Amdt. Dated: February 10, 2006

Reply to Office Action of December 30, 2005

Amendments to the Drawings:

ANNOTATED SHEET

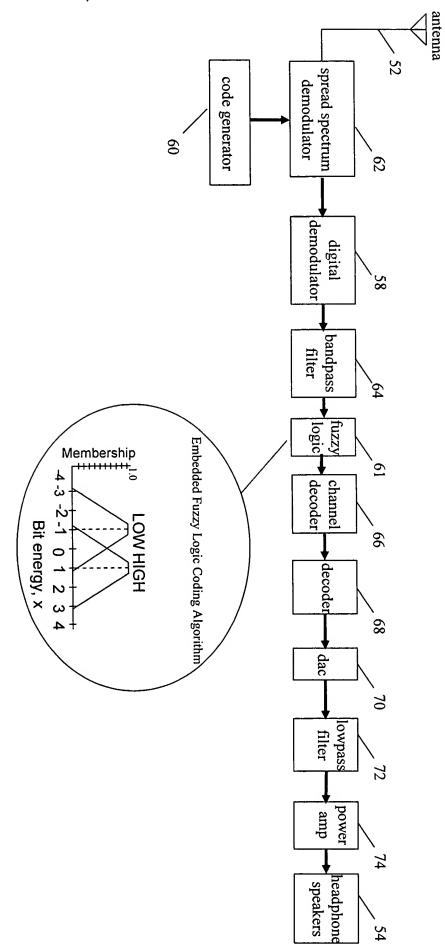
The drawings were objected to as incorporating new matter because of the altered

order of the filter in relation to other elements. Corrected drawings were required

because of the altered order of the filter in Figs. 2 and 3. More particularly, with respect

to Fig. 2, the low pass filter was shown between the ADC and encoder, thus differing

from the drawings in the parent application. With respect to Fig. 3, the bandpass filter

was shown in a different order from that shown in the parent.

Moreover, Applicant has specified in Fig. 3 that the channel decoder 66 is a

Viterbi channel decoder. Also in Fig. 3, Applicant has specified that the receiver is a

In order to expedite matters, Applicant has deleted the low pass filter of Fig. 2 as

well as the bandpass filter of Fig. 3. These filters are often included with analog-to-

digital converters and demodulators such as those shown in Figs. 2 and 3.
